Memorandum

To: Sussex County Planning Commission Members From: Jamie Whitehouse, Director, Department of Planning & Zoning; Jenny Norwood, Planning and Zoning Manager; Lauren DeVore, Planner III; Christin Scott, Planner I; Nicholas Torrance, Planner I; and Elliott Young, Planner I CC: Vince Robertson, Assistant County Attorney Date: September 2, 2021 RE: Other Business for the September 9, 2021 Planning Commission Meeting

This memo is to provide background for the Planning Commission to consider as a part of the Other Business to be reviewed during the September 9, 2021 Planning Commission meeting.

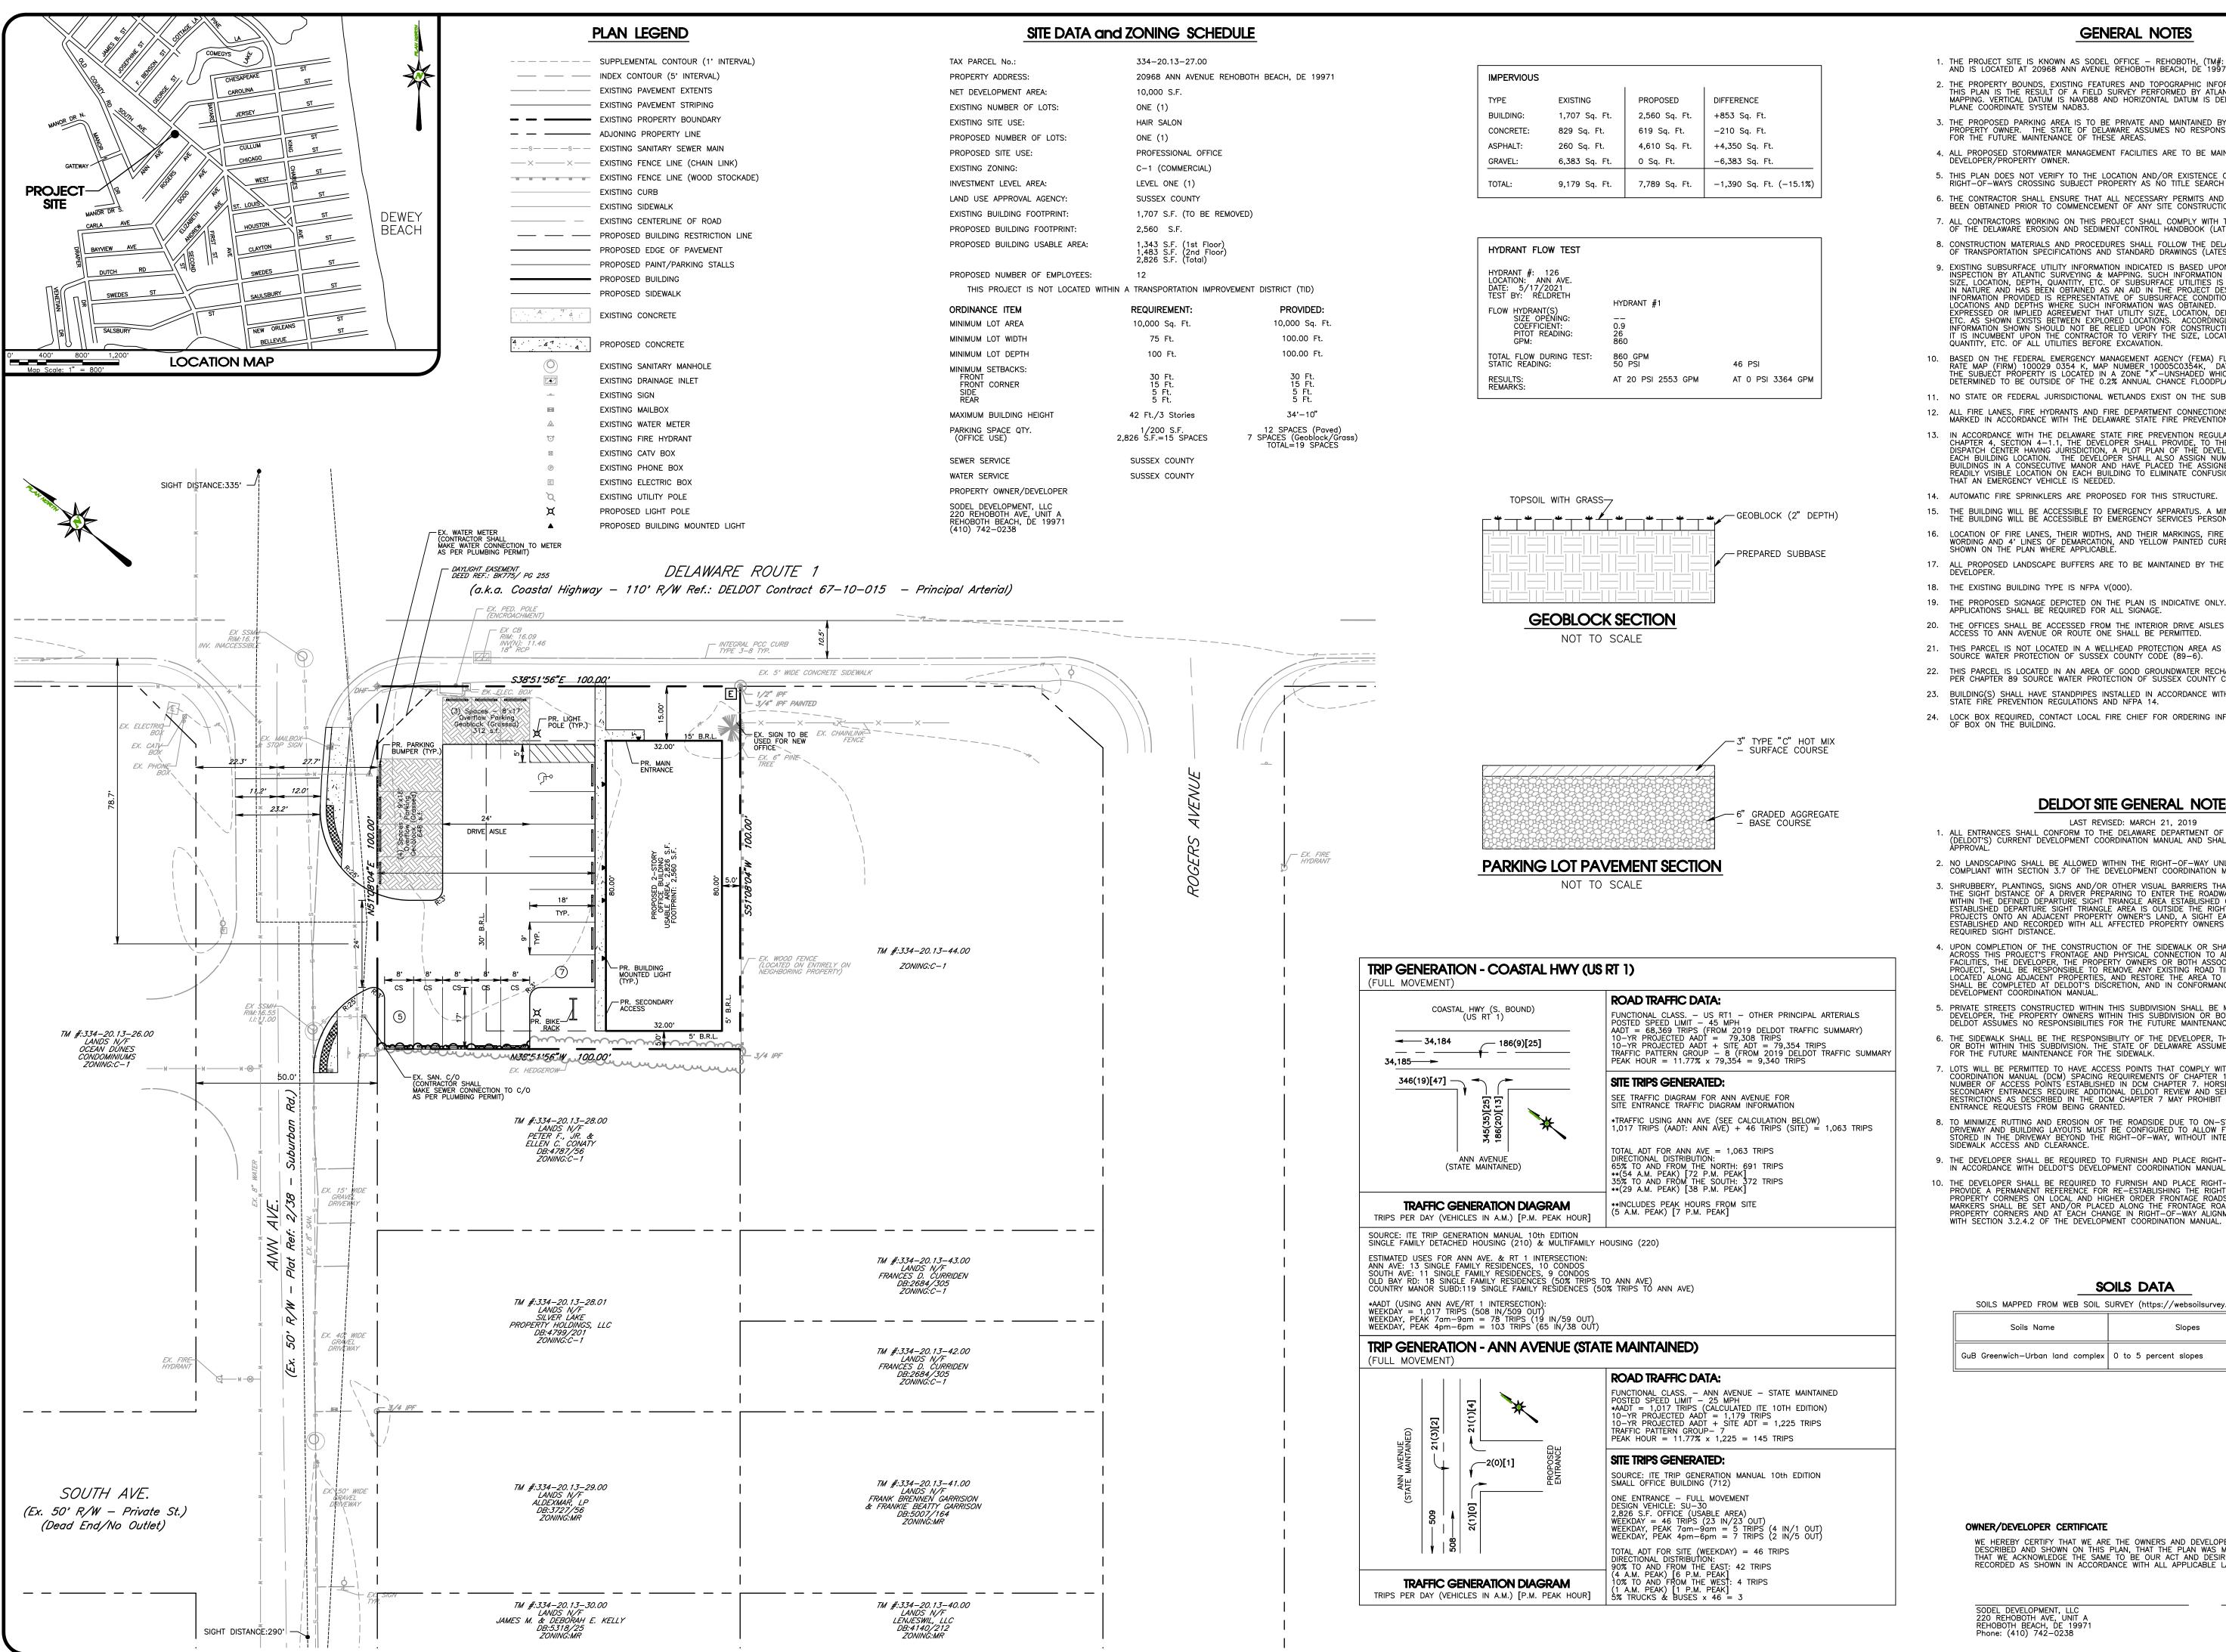
In response to the planning commissions review and questions regarding our request for the parking waiver our team is offering the following response.

- 1. Sodel has a significant portion of current employees that work remote. Either from home or from other restaurant locations. This will be the primary reason for the lower occupancy we are requesting. We have created a plan that permits an open work environment so that employees can freely work in different areas. These open areas are for the twelve to sixteen accounted for inhabitants.

- 2. The Zoning Code requires offices to provide parking at the rate of '1 per 200 square feet of <u>floor area</u>. Exclusive of basement, if not used for office or customer service purposes'. Floor Area for commercial, business, etc. is defined as 'the sum of the gross horizontal areas of the several floors of a building measured from the exterior faces of the exterior walls or from the center line of walls separating two buildings, <u>but not including attic or basement</u> storage space, ... mechanical utility equipment areas, rest rooms and stairs.' By excluding these areas, our total floor area comes to 3,734sf. This would require 19 parking spaces. However, when calculating the walking paths and circulation areas (463sf-1st level & 445sf-2nd level) we come to <u>2,826sf of usable area</u>. This would require the 15 parking spaces noted above.

This would allow us to reduce by another six spaces; which would equate to 11 required spaces. However, we are asking for your permission to provide 12 spaces. We have provided a color coded plan within this package to elaborate exactly where the 12 employees would be. This diagram also clarifies area we consider communal within a department (where employees within that department can sit down together and plan). It also clarifies areas we consider communal for all employees within the building to meet.

- 3. This site currently has two street entrances, one from Anne Ave and one from Rt.1. DelDot has required that the Rt.1 entrance be closed and that we respect the 20 foot clear sight easement on the corner. These two requirements of this site reduce the amount of space available for additional parking and vehicular circulation.
- 4. Ownerships current employee base consists of many local residents that currently do and plan to continue to bike to work when attendance in the office is warranted. For that reason, we have also added a bike rack to accommodate.
